Dust Cover Interference

Figure 1: Interference between A-spec dust cover and 22t CDX Sprocket

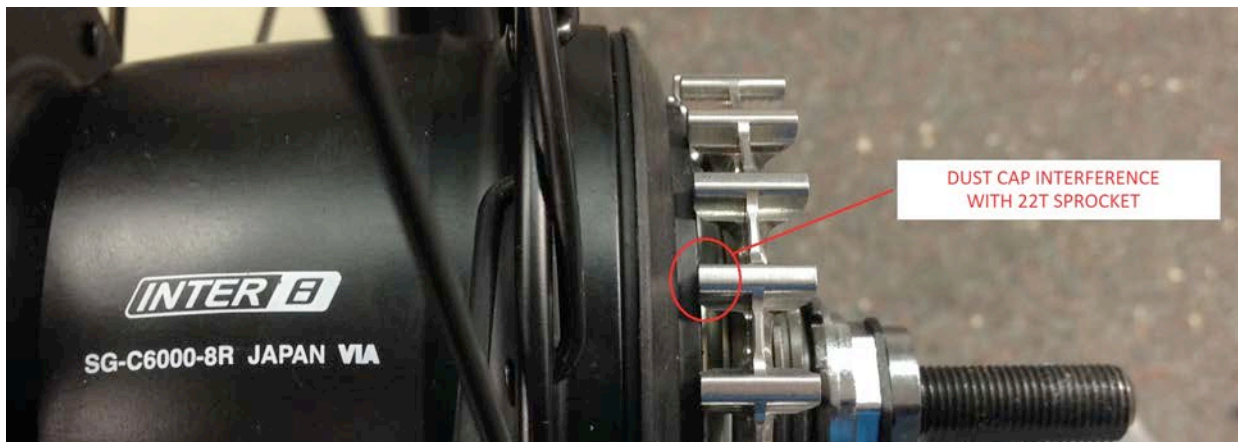
- MY 2016 Shimano Nexus 8 hubs use a new dust cover that will interfere with the Gates 22t CDX™ CenterTrack™ sprocket.
- Shimano offers a B-spec dust cover that is narrower, and will not interfere with the 22t sprocket.
- The 24t CDX sprocket will not interfere with either A-spec or B-spec dust covers.
